15.7 Radioactive Release from Subsystems and Components

The information in this section of the reference ABWR DCD, including all subsections, figures and tables, is incorporated by reference with the following [departure and supplements](#).

Figure 15.7-2 Offgas System (See Subsection 11.3)

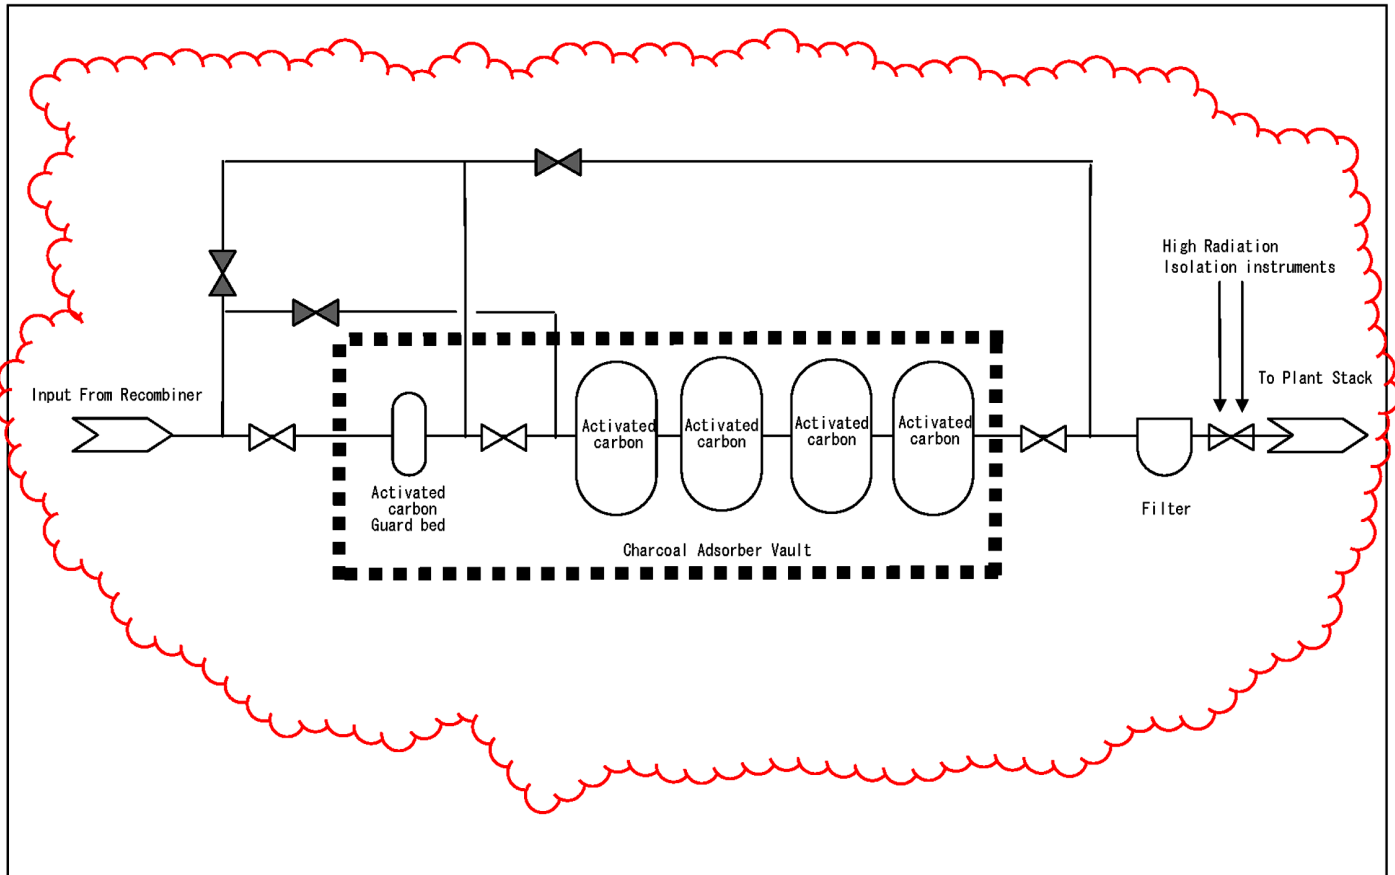
[STD DEP 11.3-1 \(Figure 15.7-2\)](#)

[STD DEP 11.3-1](#)

To evaluate the potential radiological consequences of an inadvertent bypass of the charcoal beds, it was assumed that operator error or computer error has led to the bypass of the ~~eight~~ four follow-on beds in addition to the failure of the automated air operated downstream isolation valve. It is also assumed that during this period, the plant is running at and continues to run at the maximum permissible offgas rate of 14.8 GBq/s (based upon the assumption of 0.0037 GBq/s/MWt as stipulated in Standard Review Plan 11.3) evaluated to a decay time of 30 minutes from the vessel exit nozzle. Even with the failure of the downstream isolation valve, it is not anticipated or assumed that the isolation instrumentation would fail but would instead

- (1) Flow is through a single 4.721 kg charcoal tank with an evaluated hold up time given by NUREG-0016, equation 1.5.1.6 using K_d 's for Kr and Xe from NUREG-0016.
- (2) An isolation valve prevents flow through the ~~There is no motive force to remove any significant inventory from the eight~~ follow-on charcoal tanks while in bypass and therefore no activity from these tanks is included in the final release calculations.
